ADDENDUM NO. 4

DATE: July 18, 2016
FROM: City of Grand Junction Purchasing Division
TO: All Offerors
RE: Hallenbeck Reservoir #1 Downstream Slope Repair Project IFB-4245-16-DH

Re: Alternative Borrow Source, Downstream Slope Repair, Hallenbeck No. 1 Dam, Dam ID 420125, Water Division 4, Water District 42, SEO File C-0356F

Hallenbeck No. 1 Res. - Borrow Site #2

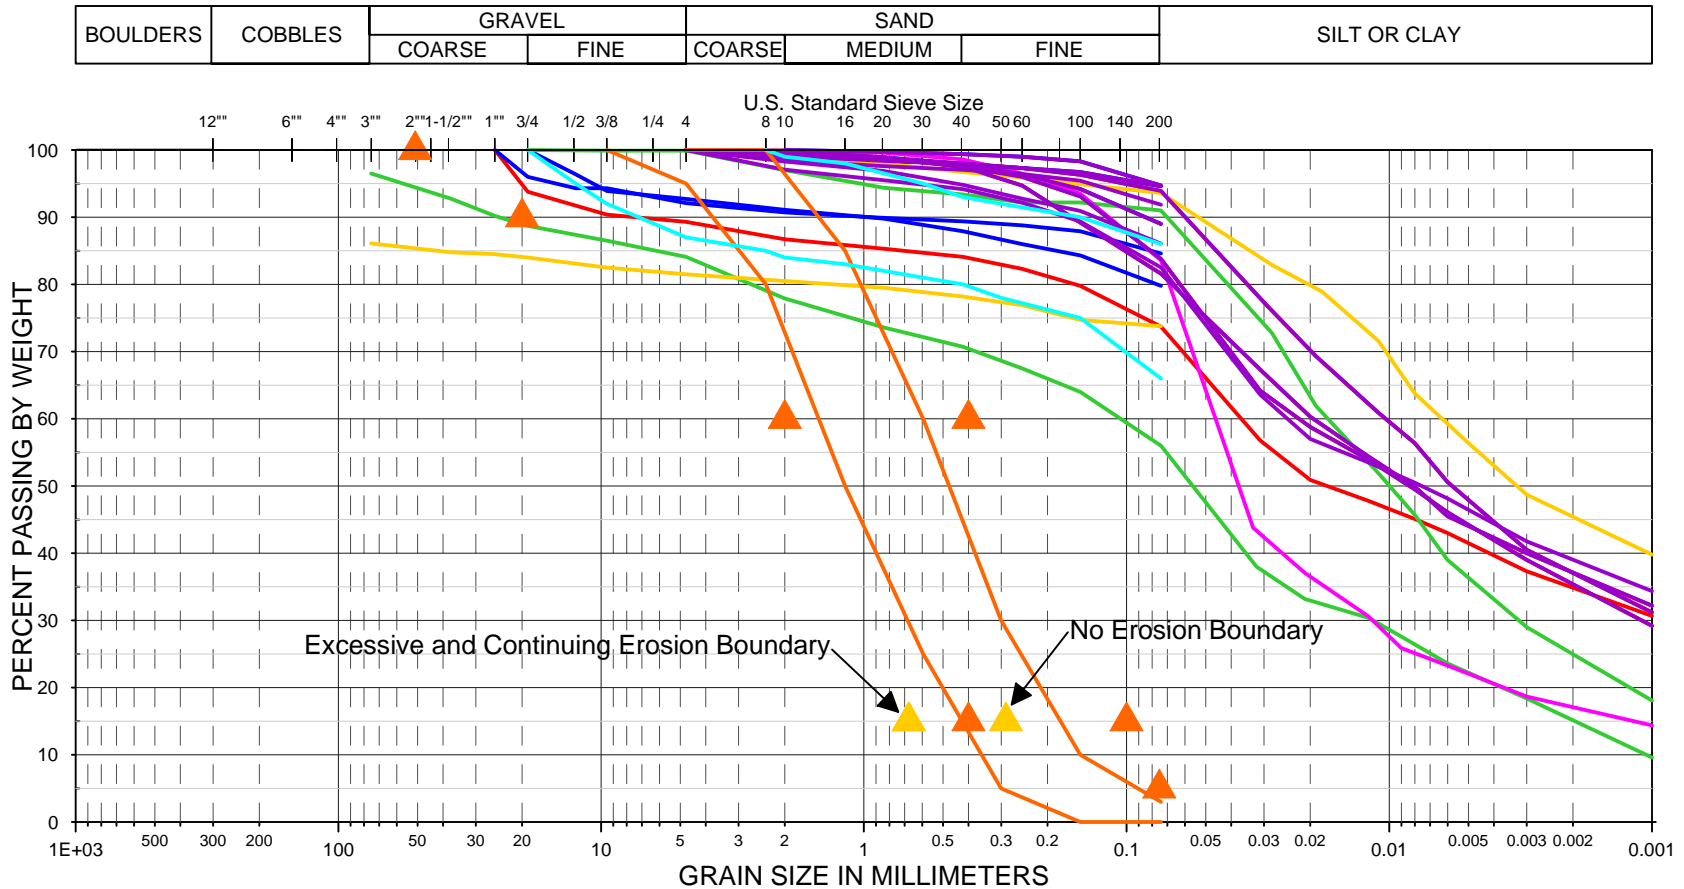
2. The Project has identified an alternative borrow source (Borrow Site #2) for excavating material to be used for the project's embankment fill. Please reference the attached report for information regarding Borrow Site #2. The design engineer AECOM has issued approval of the alternative Borrow Site #2.

The City of Grand Junction will stake the boundaries of Borrow Site #2 if required. The Contractor cannot excavate any material within 200-ft of the reservoir's dam structure. It's estimated that Borrow Site #2 could generate about 12,000 to 15,000 cubic yards of material.

Project No. 60422760	Hallenbeck No.1 Dam	Alternative Borrow Source Material Comparison	Figure 2
URS

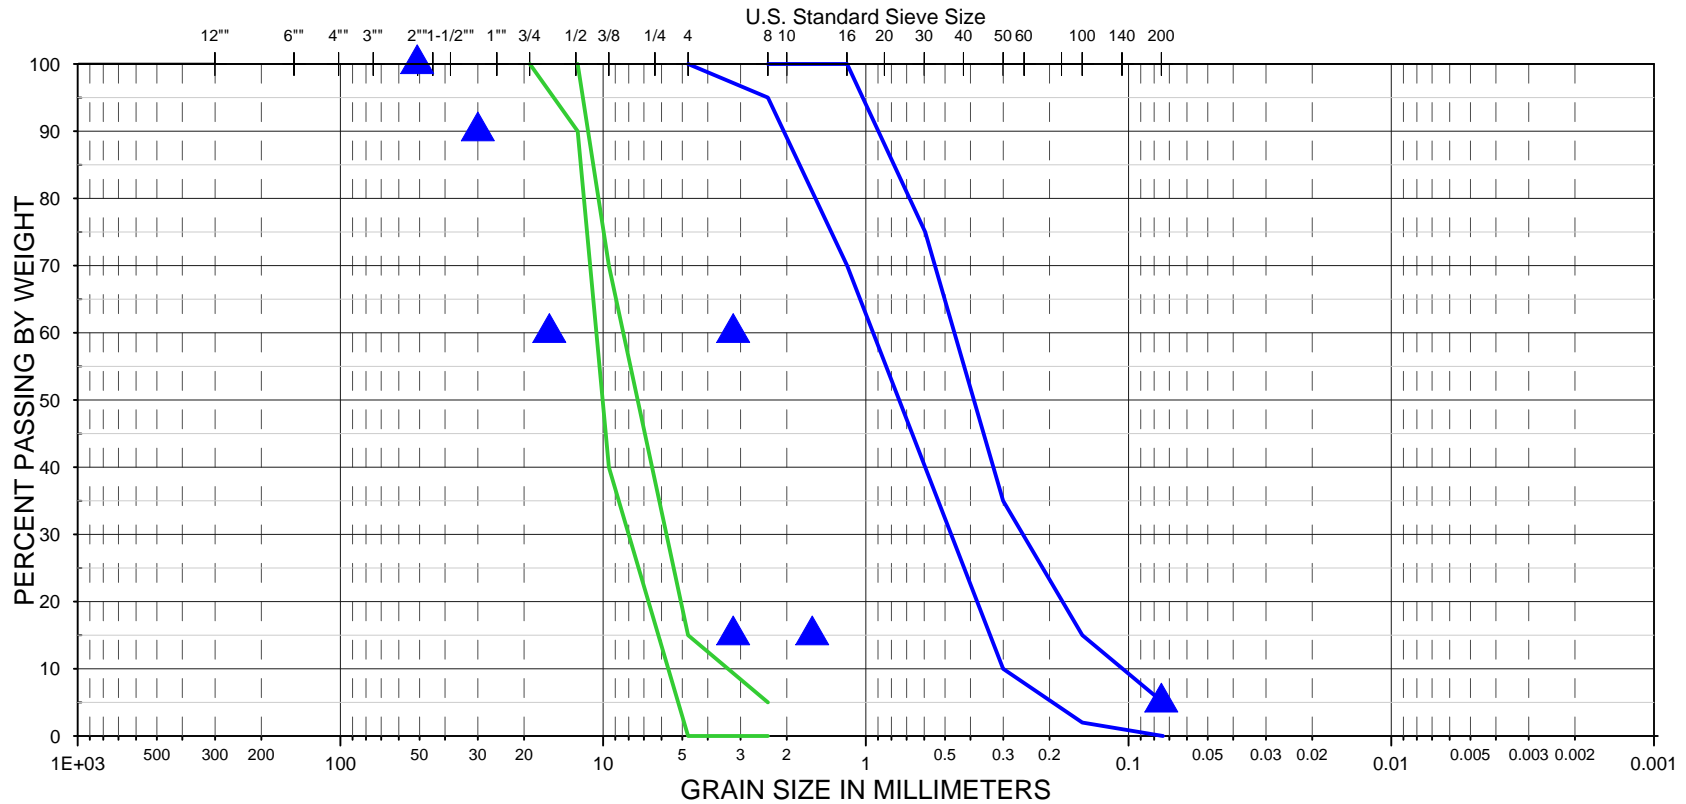
AECOM plotted the proposed borrow source gradation along with previous identified borrow gradations, as shown on Figure 2. The 2016 identified alternative borrow source material is similar to the previous analyzed materials and is therefore filter compatible with the proposed ASTM C33 fine aggregate. For the design analysis (AECOM, 2016) the buttress was analyzed using a drained effective stress friction angle of 34 degrees with zero cohesion intercept. The tested shear strength of the proposed buttress material falls within the analyzed range.

We recommend that the 2016 identified alternative borrow source could be used for buttress material. The proposed filter sand gradation meets the evaluated filter criteria, but the proposed drain gravel gradation cannot be used with the proposed filter sand gradation. Prior to final approval of the filter sand the contractor will need to obtain representative samples of the stockpile and submit in accordance with the technical specifications.

Project No. 60422760	Hallenbeck No. 1 Dam	Proposed Filter and Drain Gradations	Figure 3
URS

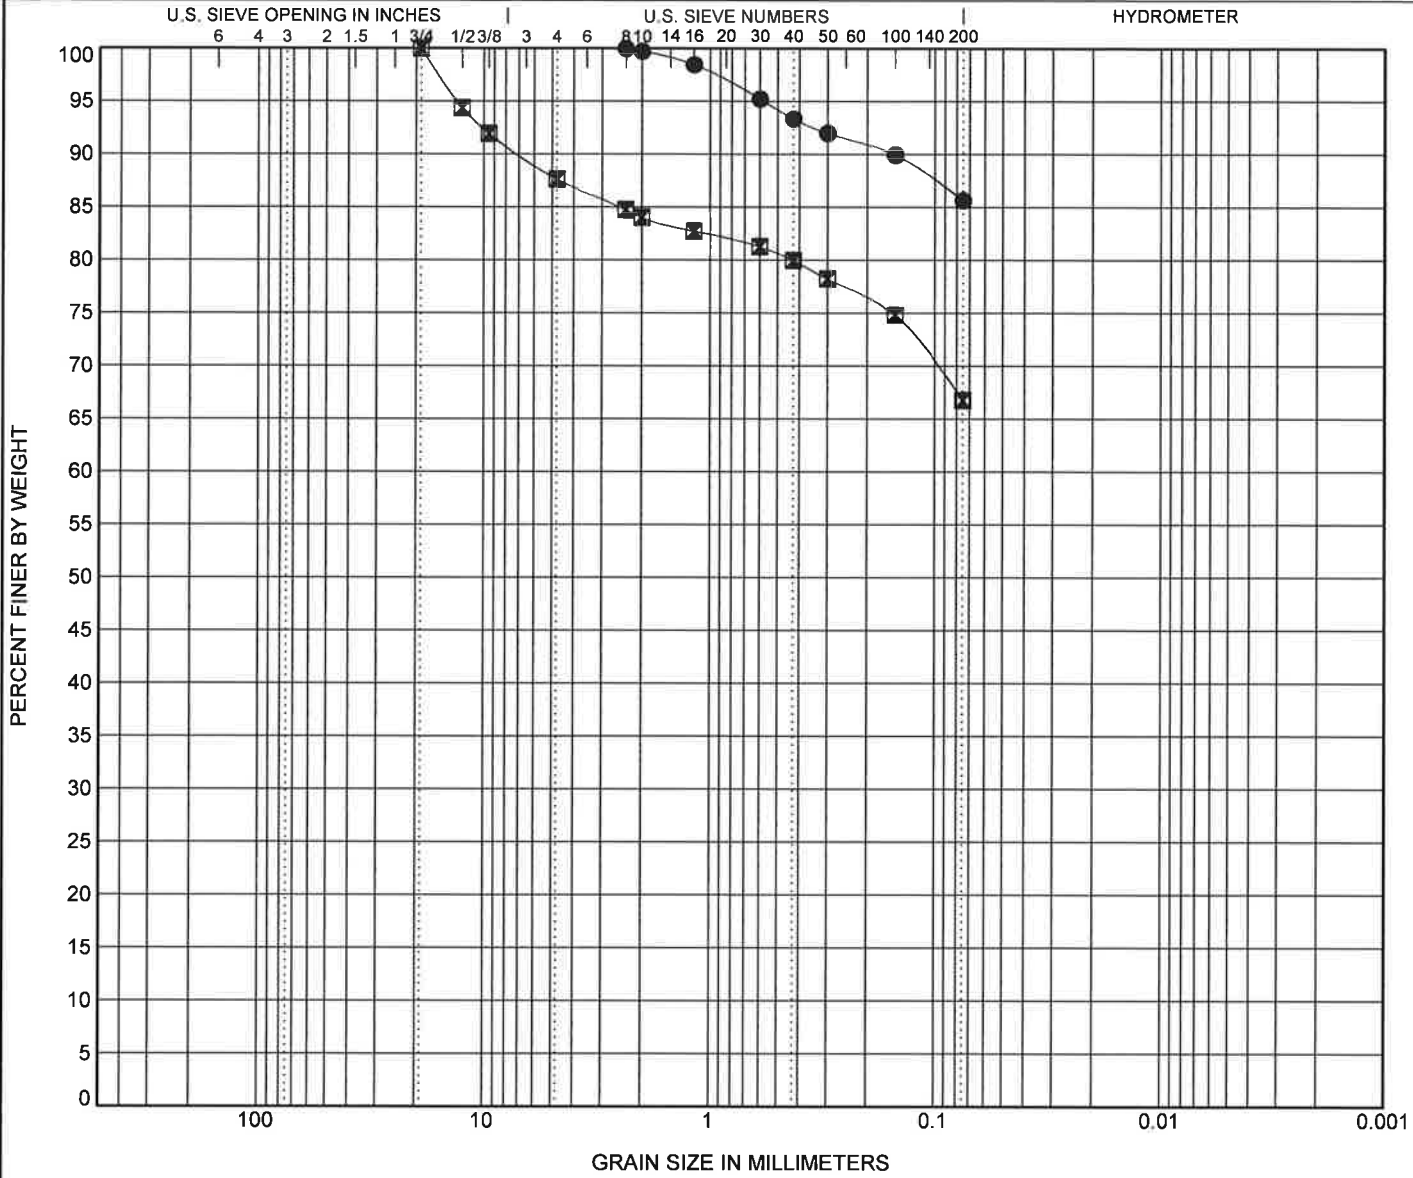
ASTM C404 No. 2 fine aggregate (natural gradation) has been proposed for filter sand and ASTM C33 No. 7 coarse aggregate has been proposed for drain gravel. ASTM C404 No. 2 fine aggregate (natural gradation) is compatible with the embankment material and can be used for the filter sand. ASTM C33 No. 7 coarse aggregate, however, is not filter compatible with ASTM C404 No. 2 fine

aggregate and cannot be used for the drain gravel if the ASTM C404 No.2 fine aggregate is used, as shown on Figure 3.
